Bulletin # SR-5K-002

Release Date: January 23, 2004

SAFETY BULLETIN

Ride Name: Cliff Hanger

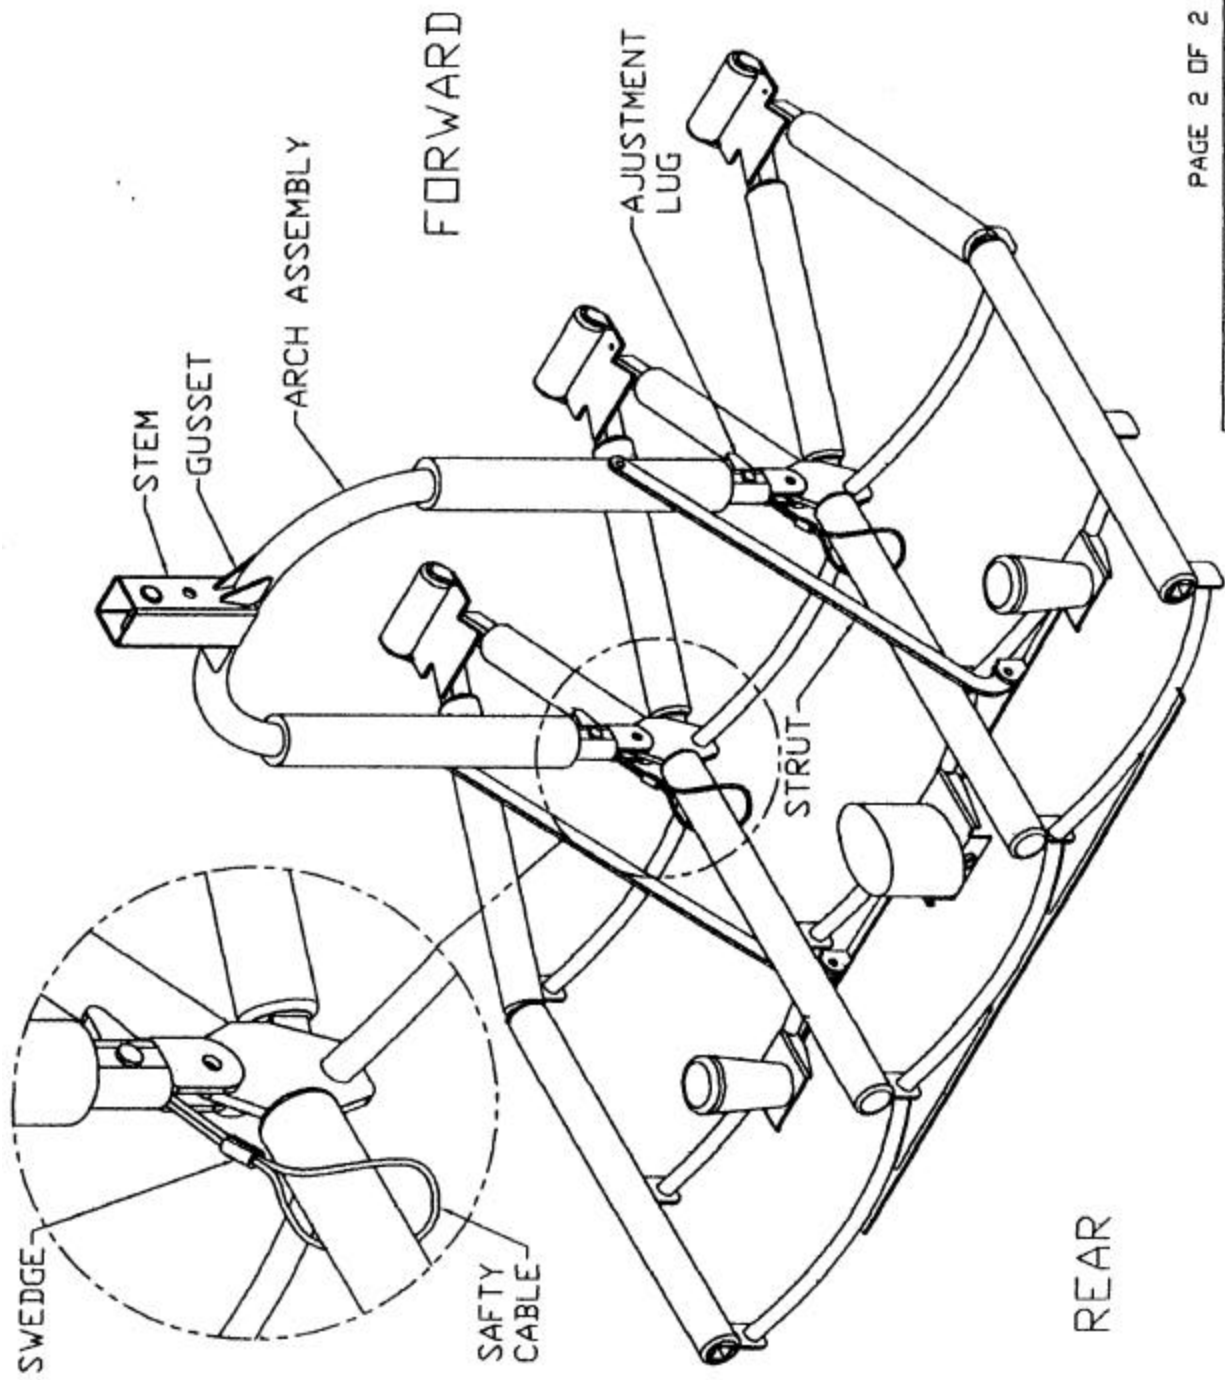
Abstract of Issue: An incident occurred on a Cliff Hanger ride operating in Florida. The cause of the incident is unknown at this time. The incident resulted from a failure in the Car Hanger Stem. The Car Hanger Stem is shown in Attachment I. As shown the Stem is connected to the Arch Assembly with four gussets that are welded to the Stem and the Arch Assembly. The failure occurred at the attachment point of the gussets to the Stem.

1. No Cliff Hanger is to be operated until the requirements of steps 2 through 6 are satisfied.
2. All welds and the heat effected areas adjacent to the welds on the gussets that attach the Stem to the Arch Assembly on each of the 10 car hanger Stems must be inspected by a certified Level II NDT Inspector using the Magnetic Particle Method. Contact Dartron at 800-421-5752 for NDT Inspection Forms. Using the Dartron supplied forms the NDT Inspector must submit a written report to Dartron documenting the result of the NDT inspection.

5. Each Car Hanger Stem must have a Dartron approved back-up system for the stem gusset joint. Dartron approved back-up systems include, a cable inserted inside the stem and attached to the passenger carrier or other Dartron designed and approved devices.
